# Service Bulletin

Bulletin No.: PI0785B

**Subject:** DTC C027B, Low Brake Pedal Feel After Master Cylinder Repairs

2515865

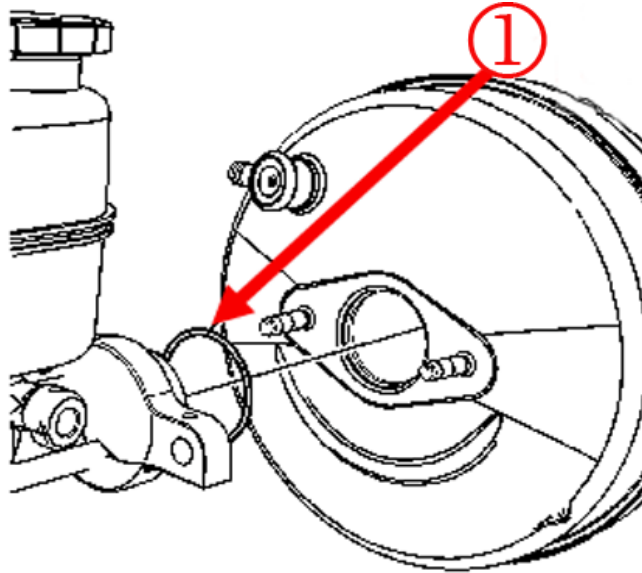
Inspect for the O-ring (1) between the master cylinder and the brake booster before performing any other diagnostics for the low brake pedal or the DTC C027B. Replace the O-ring if missing or damaged.
